Mask Set Errata

MSE908GP32_3J20X
12/2002

Mask Set Errata for 908GP32,
Mask 3J20X

SE22-POWER-UP_POWER-DOWN

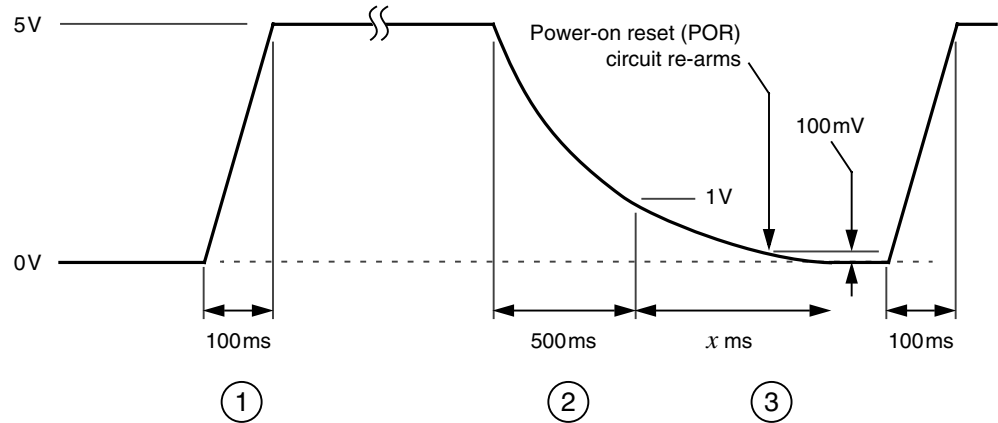
The precautions described below must be followed for 68HC908GP32 power-up and power-down, otherwise unpredictable device behavior may occur. In severe cases, the 68HC908GP32 may experience FLASH memory erasure.

1. At power-up, supply voltage rise-time should be as short as possible; less than 143ms for 5V operation; best to aim for less than 100ms.
2. At power-down, supply voltage should fall below 1V in less than 500ms.
3. Before power-up again, supply voltage must fall below 100mV for the 68HC908GP32 power-on reset circuit to rearm.

In addition, keep the external reset pin (\overline{RST}) pulled low at least until supply voltage has reached its operating level.
